30-039-05532 CANYON LARGO UNIT NP #122
HILCORP ENERGY COMPANY

Hilcorp Energy Company requests permission to temporarily abandon the MV wellbore for future potential. If the wellbore MIT does not pass, then Hilcorp Energy Company requests approval to plug and abandon the wellbore. Attached is current wellbore schematic, proposed TA and P&A schematic with procedure and reclamation plan. Pre-onsite inspection conducted 7/8/19 w/Bob Switzer (BLM) and Bryan Hall (HEC).

Re: Permanent Abandonment
Well: Canyon Largo Unit NP 122

CONDITIONS OF APPROVAL

CANYON LARGO UNIT NP 122 - PROPOSED P&A WELLBORE SCHEMATIC

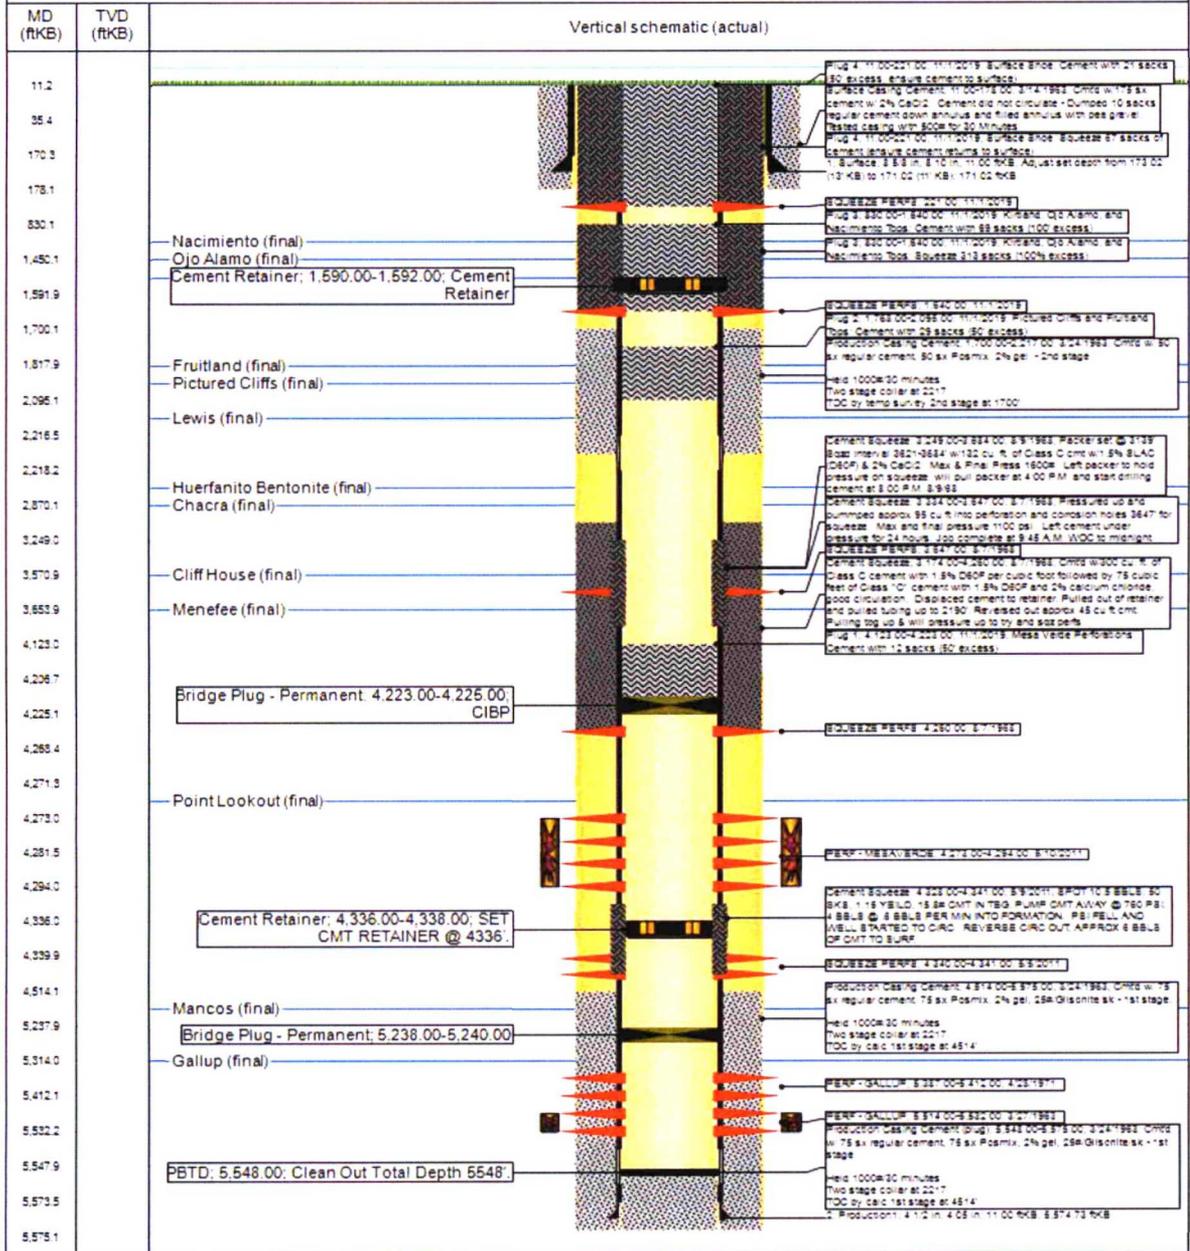
- Notify NMOCD 24hrs prior to beginning operations.
- Add Mancos Plug 4540'-4440' OCD Mancos top: 4490'.
- Add Chacra Plug 2910'-2810'. OCD Chacra top: 2890'

1. Plugging operations authorized are subject to the attached "General Requirements for Permanent Abandonment of Wells on Federal and Indian Lease."
2. Farmington Office is to be notified at least 24 hours before the plugging operations commence (505) 564-7750.
3. Submit electronic copy of the CBL for verification to the following addresses: jkillins@blm.gov and Brandon.Powell@state.nm.us . Based on CBL results inside/outside plugs and volumes will be adjusted accordingly. Please review the General Requirements document to ensure volumes meet required excess inside and outside casing.
4. Add an additional plug (3,521'-3,621') to cover Cliffhouse top at 3,571'.
